PROJECT:	CENTENNIAL PUBLIC SCHOOL ADDITION AND RENOVATION	PROJECT NO.	L13030
FROM:	BVH ARCHITECTS	DATE:	NOV. 18, 2013
TO:	CHEEVER CONSTRUCTION	ADDENDUM NO.	BID PACKAGE #5 ADDENDUM #1

CENTENNIAL PUBLIC SCHOOL ADDITION AND RENOVATION BP5 ADDENDUM 01 - EXHIBIT A

A ENL RCP - N COMMONS CORR 154 - WOOD FEATURE

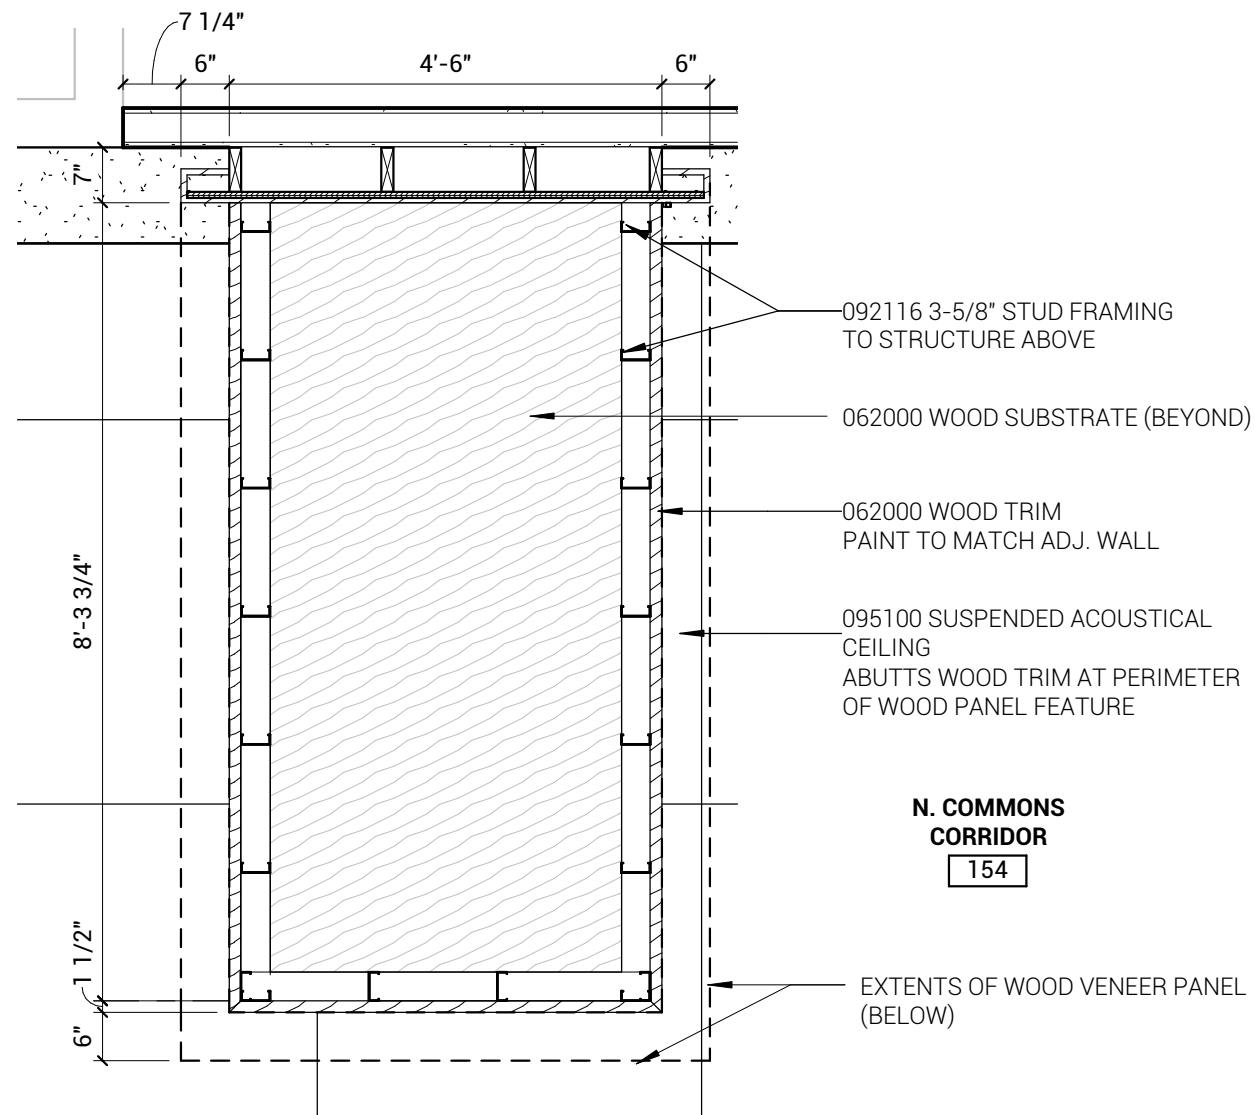
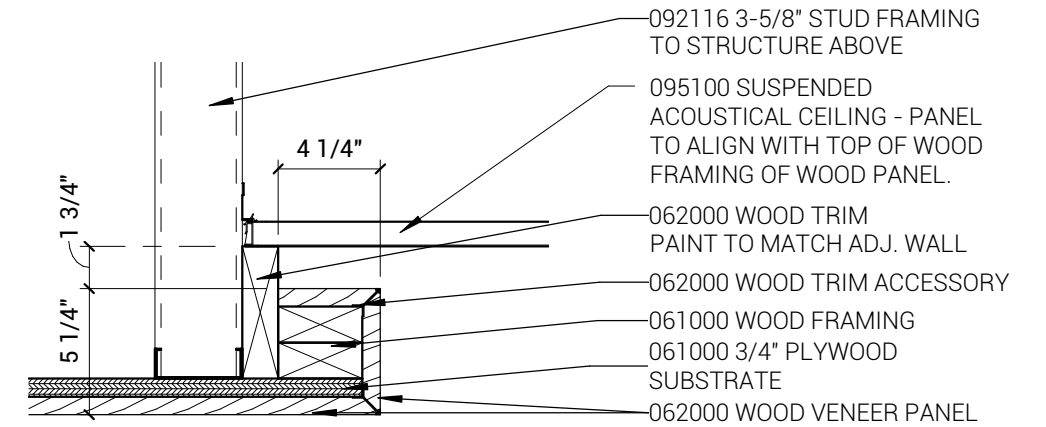
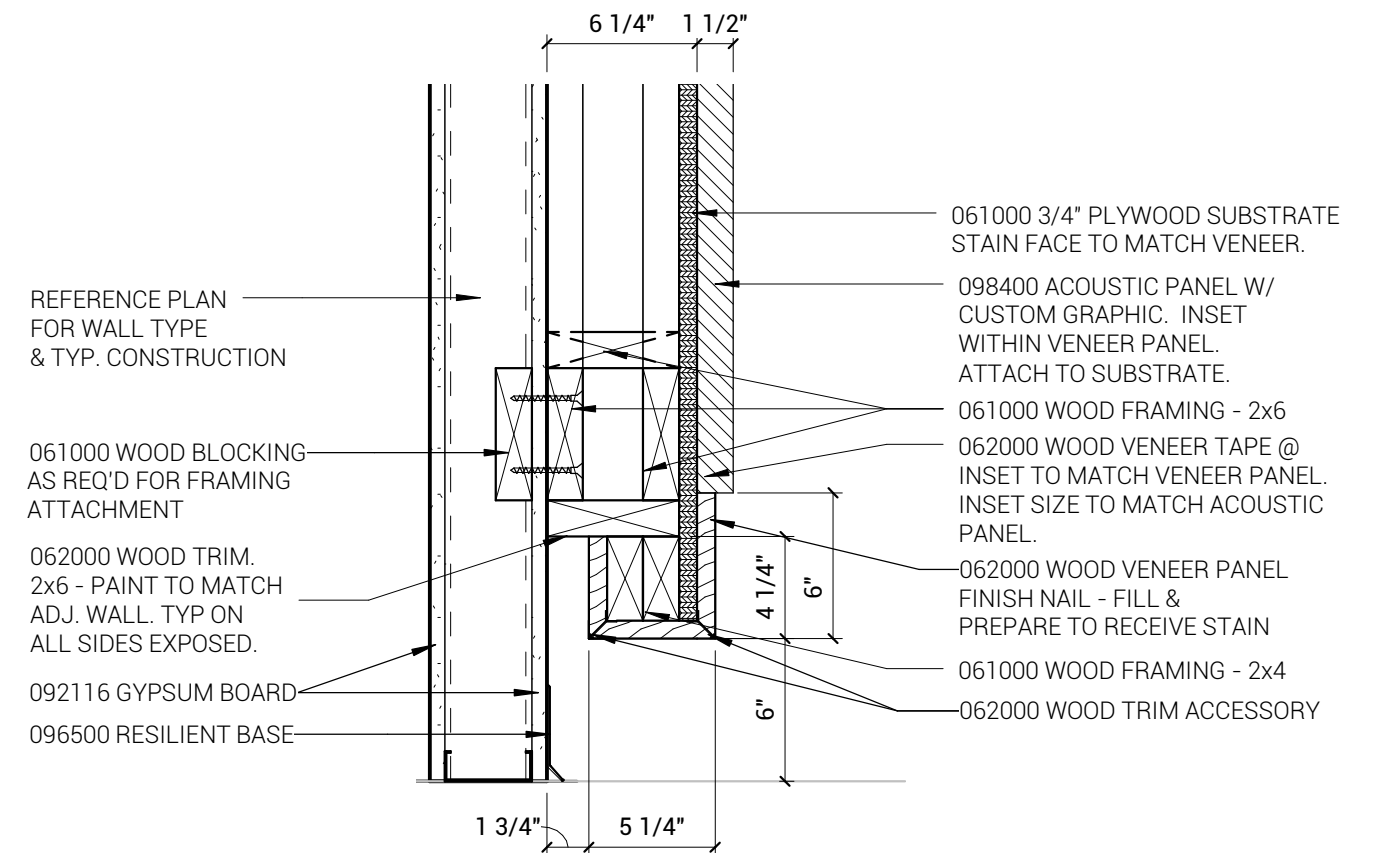
- G. Details A,B, and C, WOOD FEATURE DETAILS. See the attached 'Exhibit G'.
 - 1. Added a reflected ceiling plan, and accompanying construction details to illustrate the wood feature located on the north wall of N. COMMONS CORRIDOR 154.
- H. Details A and B, WOOD SIGNAGE FEATURE DETAILS. See the attached 'Exhibit H'.
 - 1. Added two construction details to illustrate the four wood signage features located on the south wall of CORRIDOR 146.

A ENL PLAN - WOOD SIGNAGE FEATURE
1 1/2" = 1'-0"

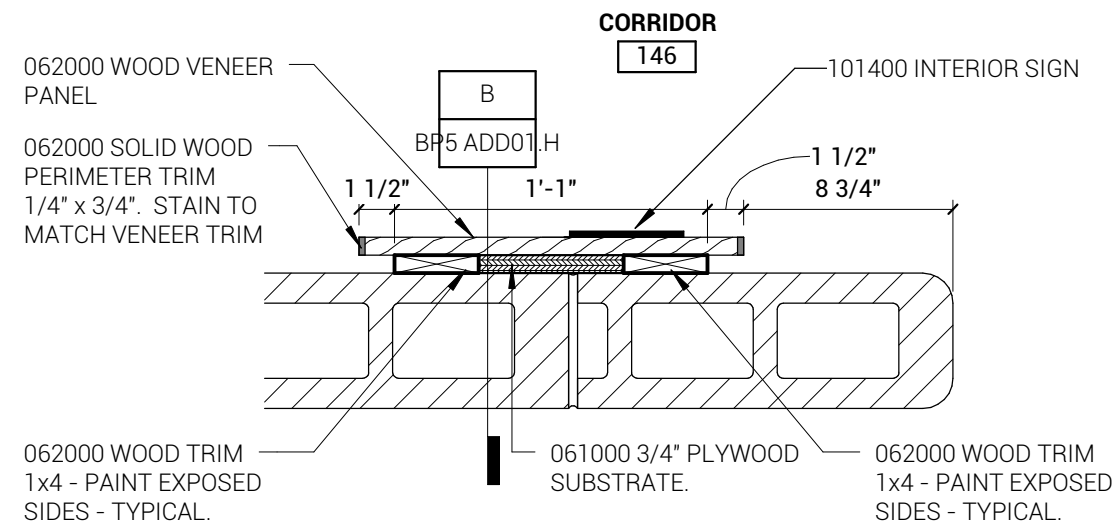
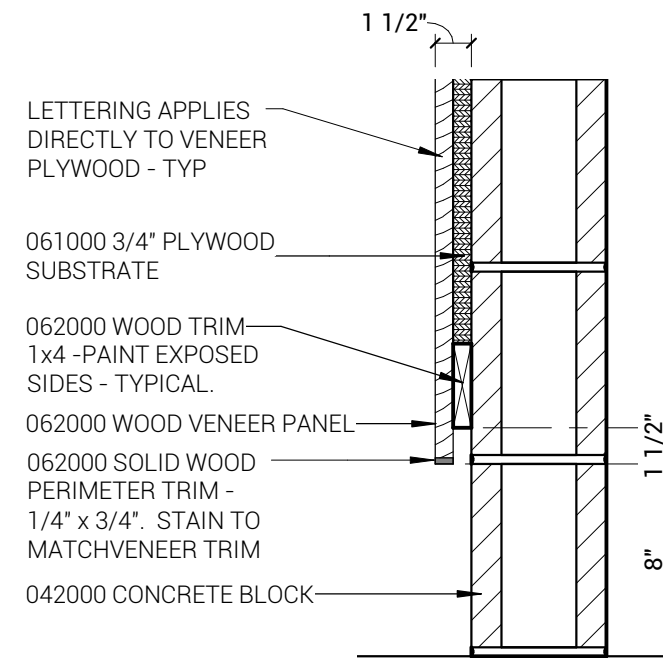
*** THESE DETAILS REFER TO THE FOUR (4) WOOD PANEL SIGNAGE PIECES ON THE SOUTH WALL OF CORRIDOR 146. REFERENCE DETAIL A1/A8.3 FOR LOCATIONS, ETC. ***
